SOLICITATION AMENDMENT
MODIFICATION DE L'INVITATION

Title - Sujet SPICA FTS Ph.0-RFP	
Solicitation No. - N° de l'invitation 9F052-130304/A	Amendment No. - N° modif. 001
Client Reference No. - N° de référence du client 9F052-13-0304	Date 2014-01-08
GETS Reference No. - N° de référence de SEAG PW-\$MTB-770-12534	
File No. - N° de dossier MTB-3-36133 (770)	CCC No./N° CCC - FMS No./N° VME
Solicitation Closes - L'invitation prend fin at - à 02:00 PM on - le 2014-01-16	
Time Zone Fuseau horaire Heure Avancée de l'Est HAE	
F.O.B. - F.A.B. Plant-Usine: <input type="checkbox"/> Destination: <input checked="" type="checkbox"/> Other-Autre: <input type="checkbox"/>	
Address Enquiries to: - Adresser toutes questions à: Champoux, Annick	Buyer Id - Id de l'acheteur mtb770
Telephone No. - N° de téléphone (514) 496-3428 ()	FAX No. - N° de FAX (514) 496-3822
Destination - of Goods, Services, and Construction: Destination - des biens, services et construction:

<p style="text-align: center;">FTS</p> <p style="text-align: center;">SPECIFICATION</p>	<p>SAF no.: SRON-SAFARI-SP-2013-003</p> <p>Inst.no.:</p> <p>Issue: draft 0.33</p> <p>Date: 02-09-2013</p> <p>Category:</p> <p>Page: 2 of 25</p>

Figure 7 - Block diagram of the warm FTSCU electronics connected to the cryogenic FTSM

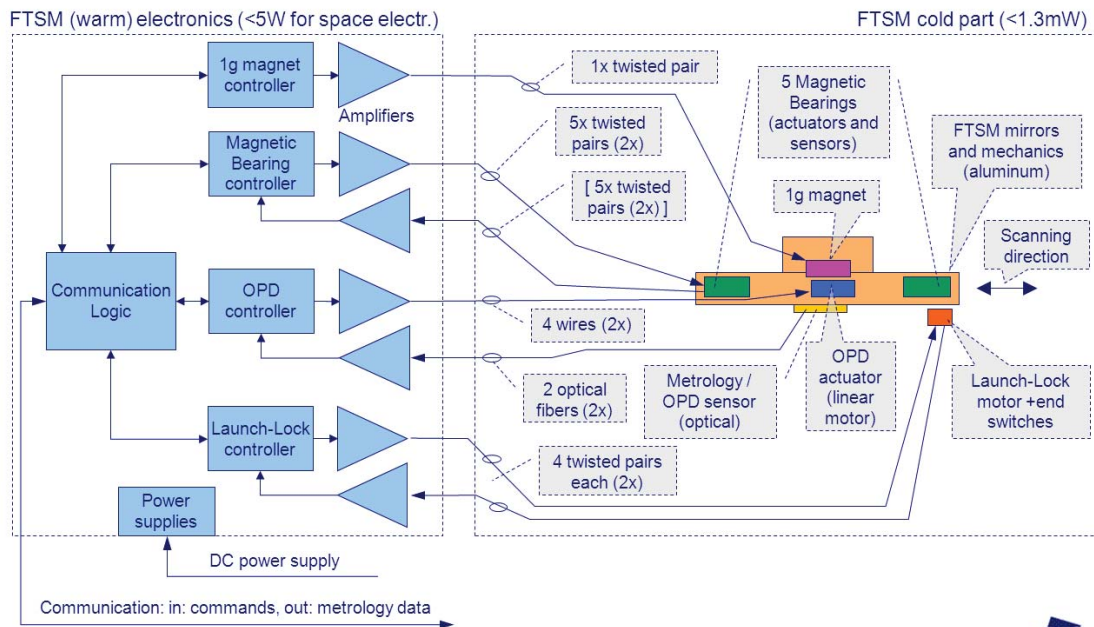
Remark:

Update text in Figure 7.

- Make number of wires consistent with 6.4.11
- Thermistors
